Mitsubishi Motors North America, Inc.
PARTS BULLETIN

Outlander / Outlander PHEV
Front Bumper Mislabeled Issue

No: PB-DG-001-26

Model: Model Years 2025-26
Outlander / Outlander PHEV

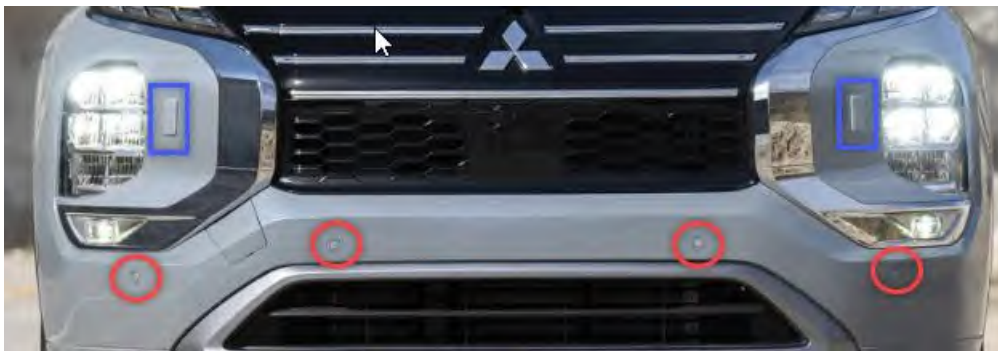
Old Design: No mounting holes on inside of vertical reinforcements

New Design: Equipped with mounting holes on inside of vertical reinforcements (shown circled in red)

- Inspect inventory and separate parts by design (refer to pictures below).
- If parts are the old design, no action needed.
- If parts are the new design, re-label box to correct part numbers (Refer to Table A).
- Adjust inventory records accordingly to ensure the correct part number and quantity is shown in dealer management system.
